Pre-Lodgement Meeting Response

601 PACIFIC HIGHWAY

Council Advice		Architectural Response
COMMENTS 2.1 FSR	a) Minimum non-residential FSR	Justification Provided by Urbis
COMMENTS 2.2 Building Height	a) Plant levels - 8m/6m	Refer item 2.5-b for plant room strategy. The plant area has been allocated that is appropriate to achieve PCA-A grade level of servicing.

2.2c Building Height – Tower Levels

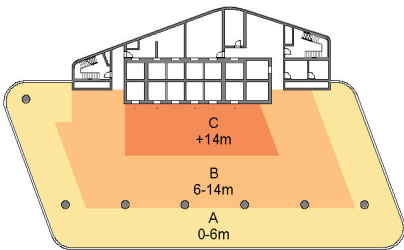
b) Podium levels - 4m - floor to floor	Refer Item 2.2b. – Justification Provided by Arup (Please refer to Arup’s Justification Letter)
	c) Tower levels - 3.75m - floor to floor	Refer Item 2.2c. – Justification Provided by Arup (Please refer to Arup’s Justification Letter)

The floor to floor heights are appropriate in order to achieve PCA-A grade quality office space.

Floor-to-floor heights for typical A and Premium grade office floors are 3.75 to 3.85m in order to maintain a minimum 2.7m ceiling and accommodate a 150mm raised floor, depending on the core location, floor plate size and mechanical system selection. A floor-to-floor height lower than 3.75m would limit the mechanical system selection and restrict the flexibility for a commercial office floor.

While the proposed 3.75m floor-to-floor heights are in excess of the 3.6m standard in the North Sydney DCP 2013, 3.6m would be inadequate. The proposed reference design of 3.75m floor to floor is appropriate based on likely structure sizing and is comparable to the recently approved and constructed commercial buildings of similar quality within North Sydney Council area.

2.3 Podium Heights

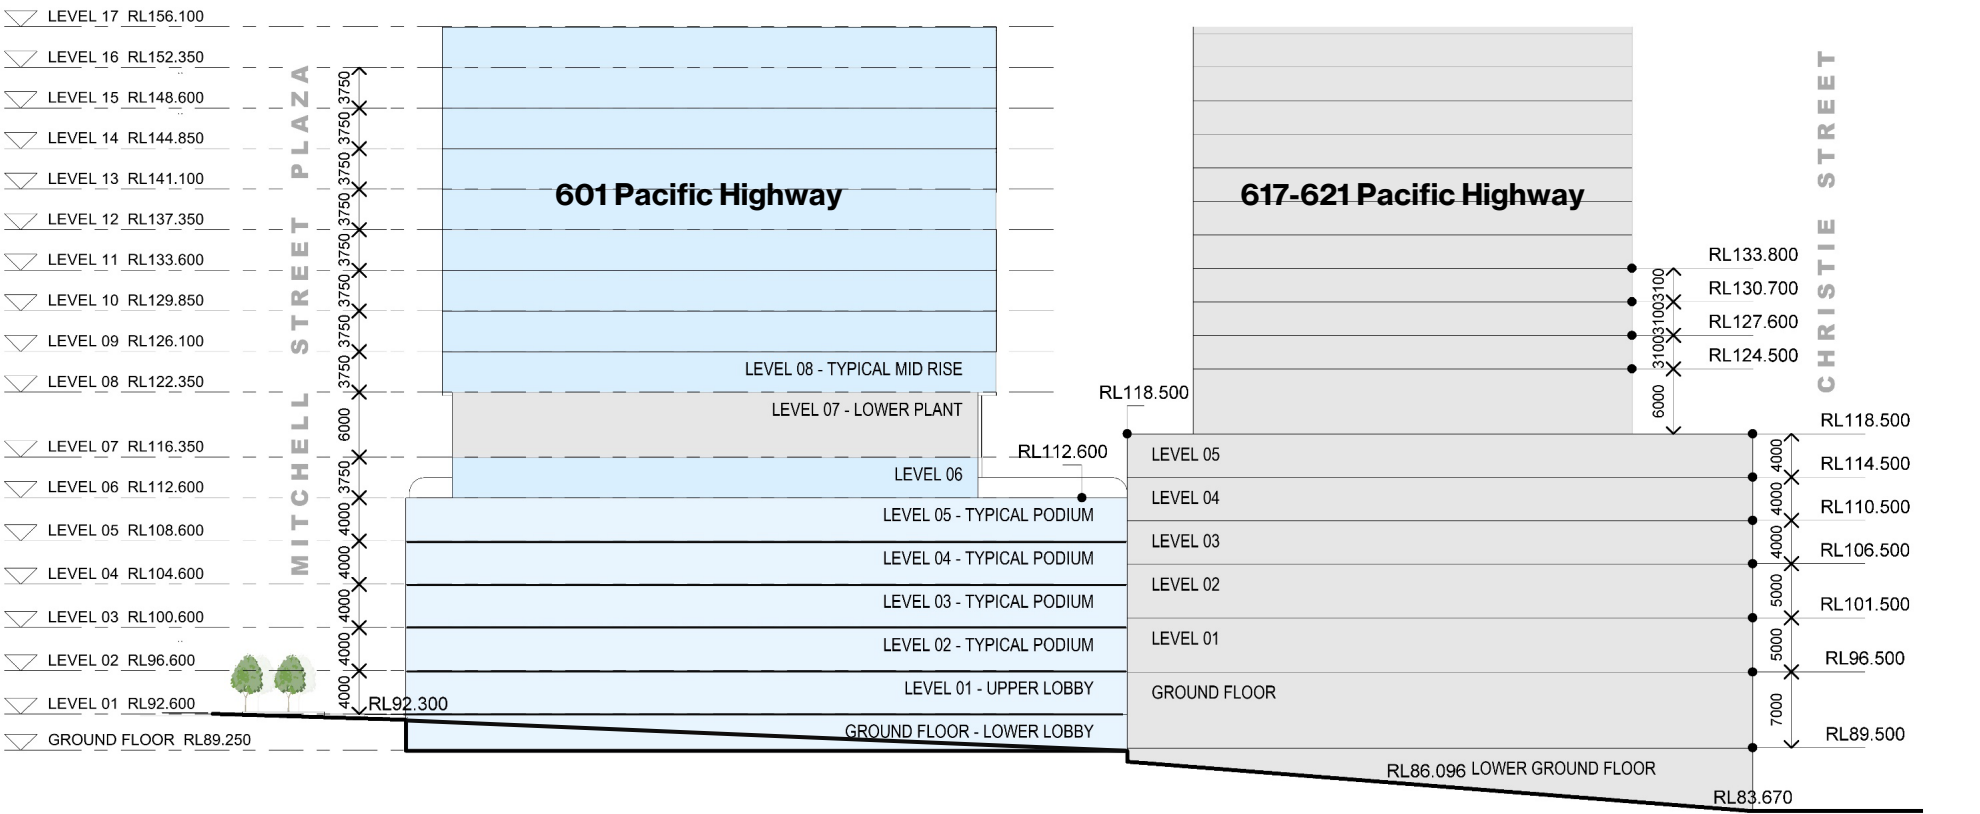
f) Maximum building height should be lower than 617-621 Pacific Highway (180m) / 2036 Plan Principle	Justification Provided by Urbis
COMMENTS 2.3 Podium Heights	a) Podium height/Oversize	Refer Item 2.3. The additional floorplate depths result in requirement to increase floor to floor beyond that of a typical level. This is caused by deeper structure and deeper floorplate requiring increased ceiling heights Justification Provided by Arup (Please refer to Arup’s Justification Letter)

The 2036 Plan incorporates specific built form parameters for the subject site that have been informed by detailed urban design analysis. It is considered that the built form parameters of the 2036 plan prevail to the extent of any inconsistency with the DCP 2013 particularly given the terms of the Ministerial Direction .

The indicative concept proposal has been designed to achieve compliance with the 2036 Plan podium street wall heights controls. However, the site’s topographical conditions do not allow strict compliance with the five storey street wall height. The varied podium height is a direct response to the gradient, which falls from the north-east by 2.5 metres to the south and 3.5 metres to the west. This is a long accepted urban design response to site conditions.

Notwithstanding the minor variance, at the site’s most visible and prominent frontage to the intersection of Atchison Street and Mitchell Street, the podium expression establishes a five storey street wall height. This is consistent with the 2036 Plan and establishes a consistent podium datum line that aligns to the prevailing streetscape in the surrounding locality.

East West Section

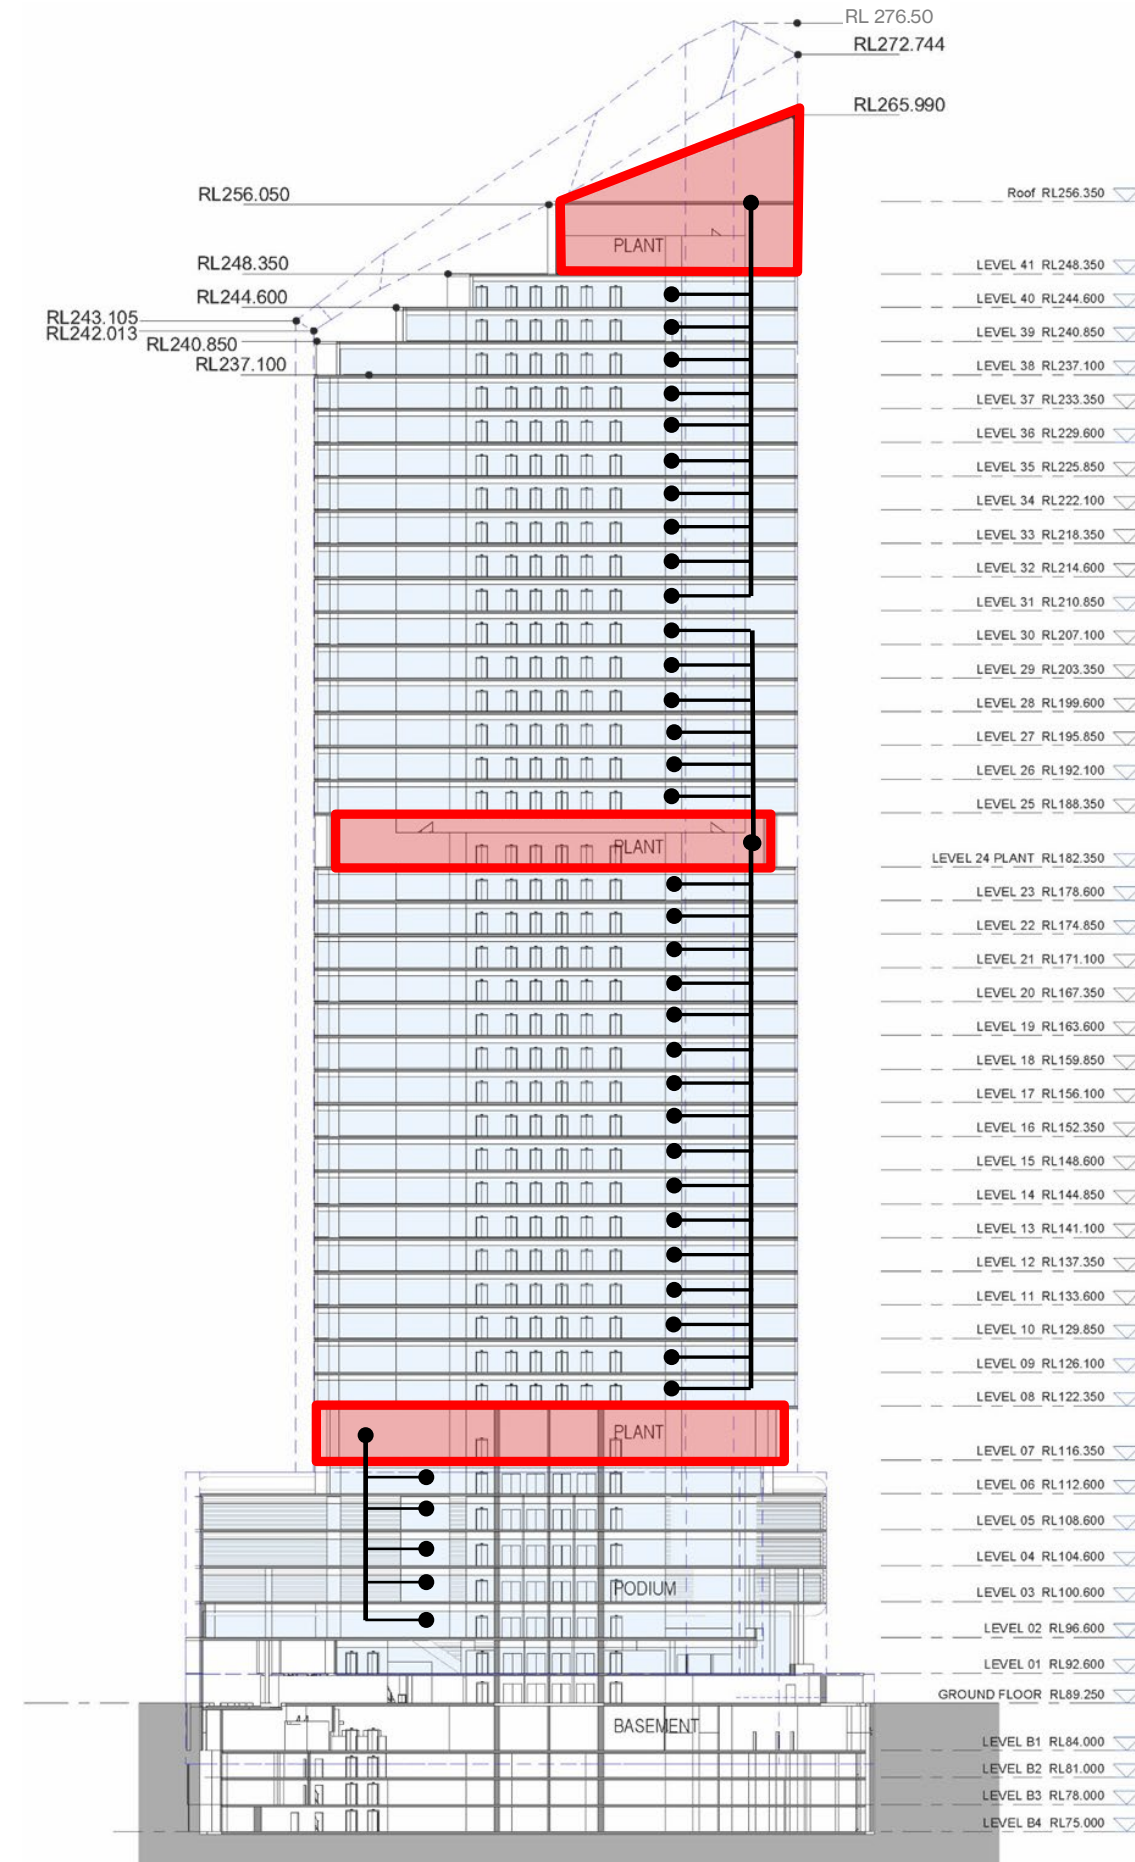
b) Three plant room levels	Refer Item 2.5-b. The three plant rooms are required due to building height and additional loading caused by larger podium floor levels. The reference design assumes a traditional service solution that serves podium floor from a single low rise plant (above podium). The low rise and some high rise floors are served from mid level plant. The roof plant serves remaining high rise levels. Additionally roof plant due to floorplate reduction (caused by the solar plane) has been designed as two storey plant to accommodate lift overrun (8m+) and heat rejection on upper level. Justification Provided by Arup (Please refer to Arup’s Justification Letter)
COMMENTS 2.6 Tower Floorplate Layout	a) Blank walls treatment (Atchison St & Mitchell Plaza)	Refer Item 2.6. The ‘blank’ appearance of the core element is in fact caused by the louvre privacy screens applied to bathroom amenity windows located in the core. While the Council report states availability of view to east, the design team has prioritised privacy to neighbouring residential properties. The design will be subject to DA.

Mid level plantroom:

The driving item for the mid plant room height is the upper chamber substation as Ausgrid's standard (NS113) mandates 4.2m clear height - 3.2m for the substation and 1m for the cabling or trench. In addition, it is necessary to hoist transformers to ground level for replacement which at this height will need a lifting beam or drum depth of circa 1.2m. If we consider the sum of these 2 dimensions (5.4m) plus structure (slab and beam thickness), it is possible to conclude that 6m is the appropriate height for the mid level plant room. It is also pertinent to refer that at this level the plant rooms are proposed as double stacked for the other half of the floor plate by having ventilation plant on top of chilled water plant and switch rooms. In conclusion, 6m is tight if structure is to be considered.

Low level plantroom:

The purpose of this low level plant room is to accommodate ventilation plant. The necessary equipment (Air Handling Units and duct work) require a minimum of 5m clear headroom. Subsequently, it is necessary to consider the floor structure (slab, beams, raised floors) and for this reason 6m is also considered as the adequate height for the low level plant room.

East West Tower Crown Section

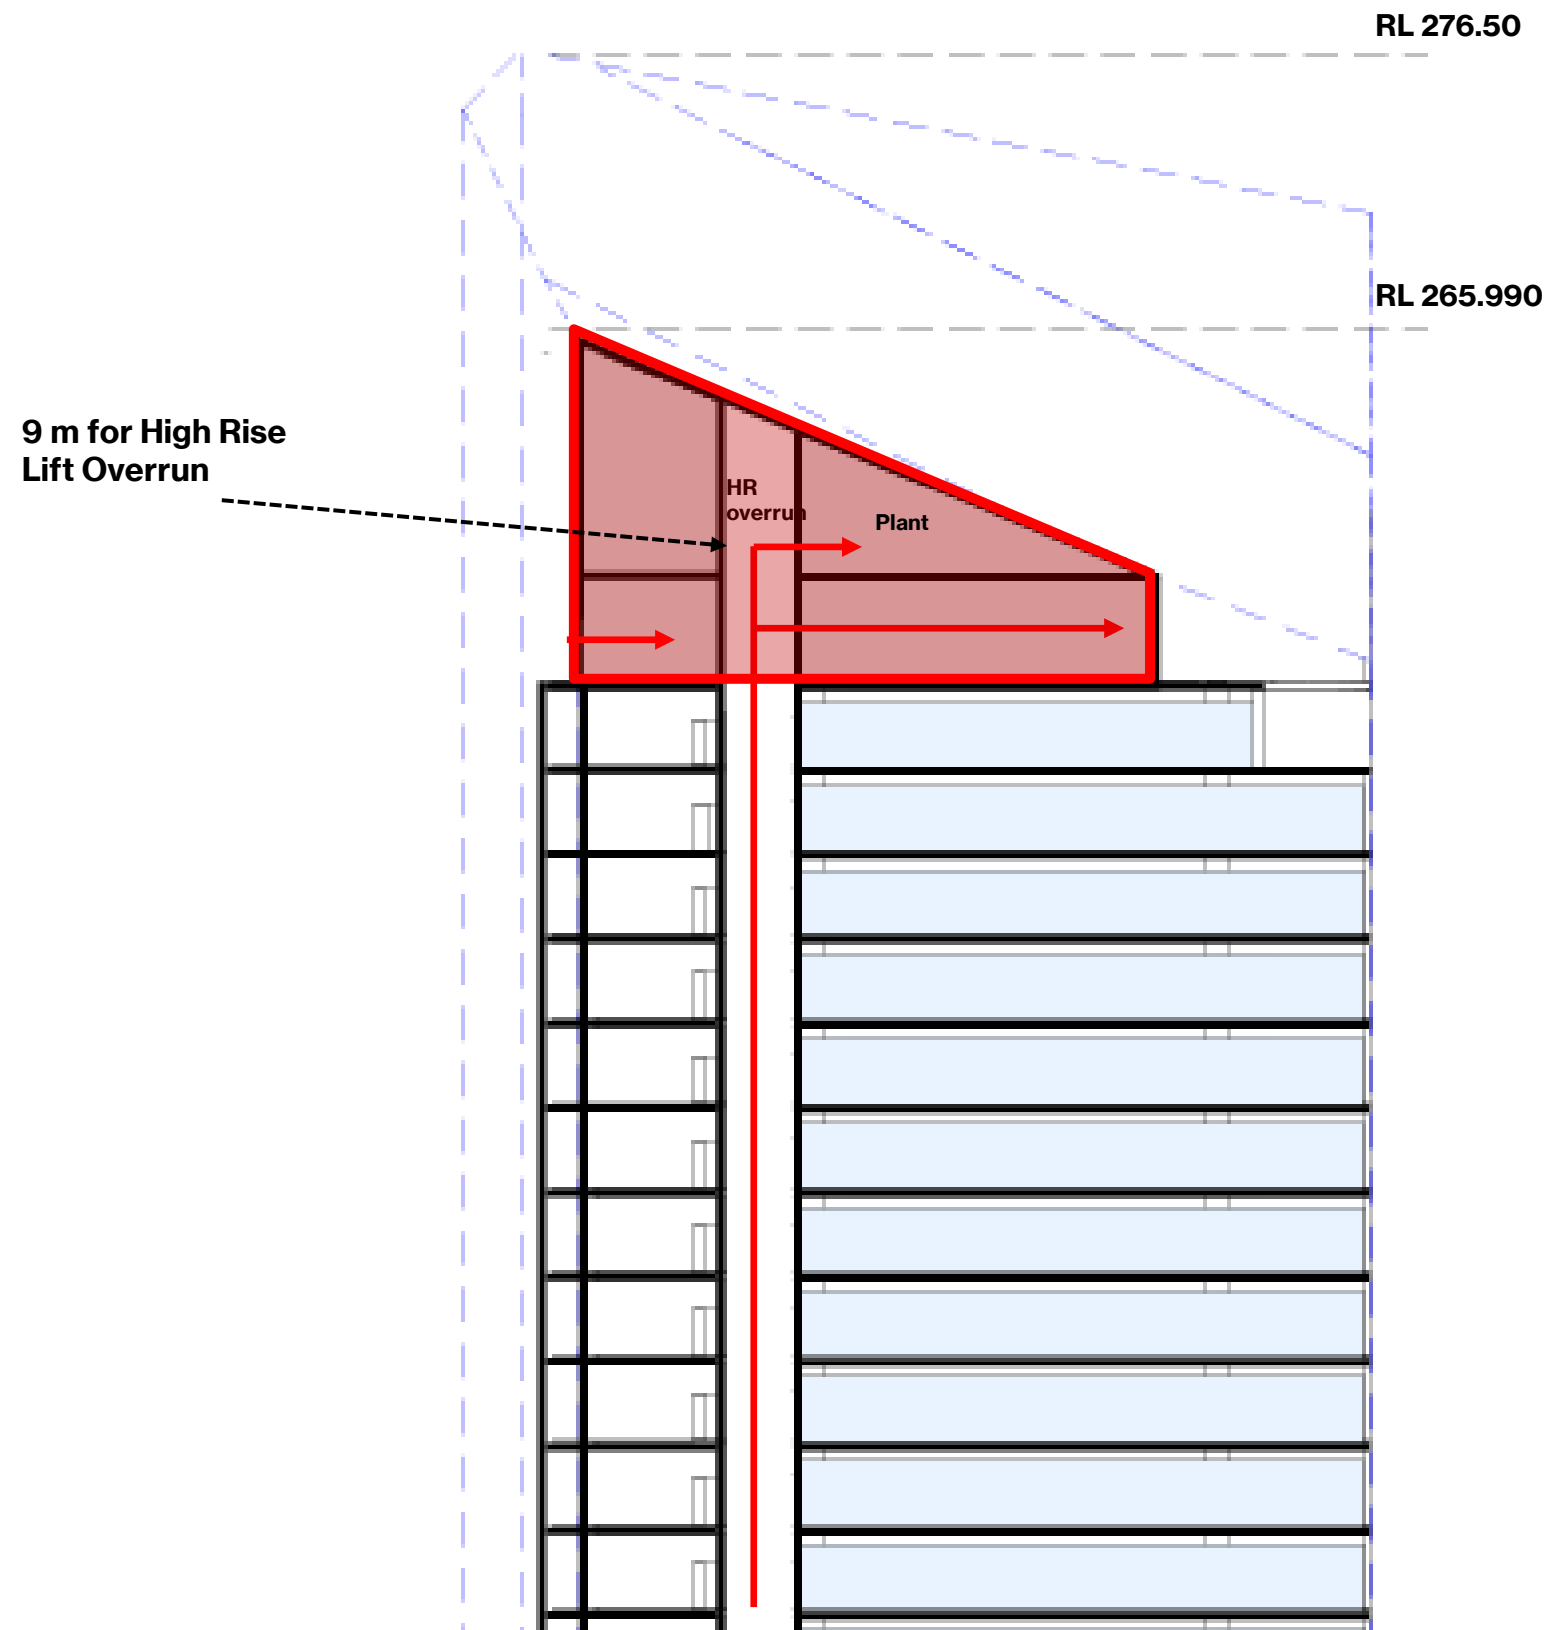
d) Roof - 9.65m structure	Plant room justification for double stacked plant room + 9m lift overrun.
	e) Above roof - 10.51m void envelope	Need Client instruction – Architectural Roof Features

This is effectively two plantroom floors. On the lower level it is necessary to accommodate tanks and ventilation plant with cooling towers and heat pumps on the level above, hence, 8m height cannot be considered a generous dimension for the top plantroom. The ventilation plant requires 3m clear minimum, necessary for duct work across the floorplate at high level to risers plus 2.1m clear for access per unit space beneath. On the top level, 5m for cooling towers (incl deck/structure), which is tight as normally the recommended headroom is 6m+.

The plant room volume for the proposed scheme is also justified for the fact that it should incorporate the lift overrun. It allows access to each stepped landscaped open space on the roof. The required overrun for high rise lift is 9m.

Lastly, the plantroom and roof were designed as an architectural feature that will add to St. Leonards Skyline. As stated and requested on the NSDCP Part B, point 2.4.6, the roof has been designed to provide character to the building and to St. Leonards Skyline. The roof design is integral part of the overall design of the building and the rooftop plant room is contained in a single structure and is not perceptible from any point on the ground floor.

2.8a Mitchell Street Plaza

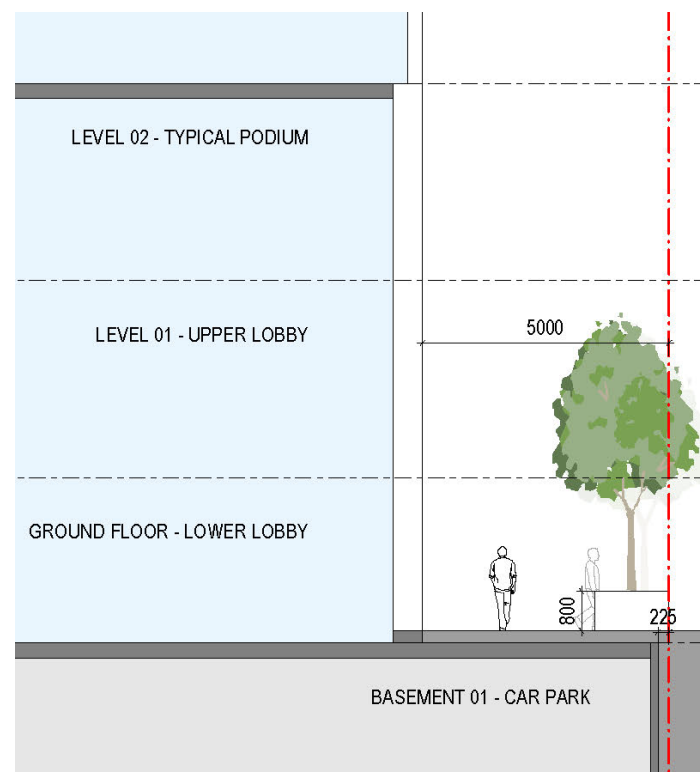
COMMENTS 2.7 Ground Level Activation	a) Fine grain retail space (Atchison St & Mitchell Plaza)	Refer Item 2.7. The reference design has been amended to include retail tenancies along side Atchison Street and Mitchell Street Plaza
COMMENTS 2.8 Mitchell Street Plaza	a) Basement levels should be consolidated beneath building footprints to allow for adequate deep soil zones	Refer Item 2.8a. The building utilised existing basement excavation and as such the proposal is constrained by the existing layout. However the diagram, refer Item 2.8, shows ample zone of deep soil planting outside of basement zone.

Council has raised interest in densifying biophilia in Mitchell Street Plaza most specifically on the Western side along 601 Pacific Highway frontage by introducing deep soil planting on the 5m setback zone.

The proposed design for 601 Pacific Highway retains the car park structure of the existing building and the diagram to the left illustrates the extension of the existing car park comparatively with the 601 site area. It is possible to understand that there is not enough area for deep soil planting hence another solution for introducing landscape must be considered.
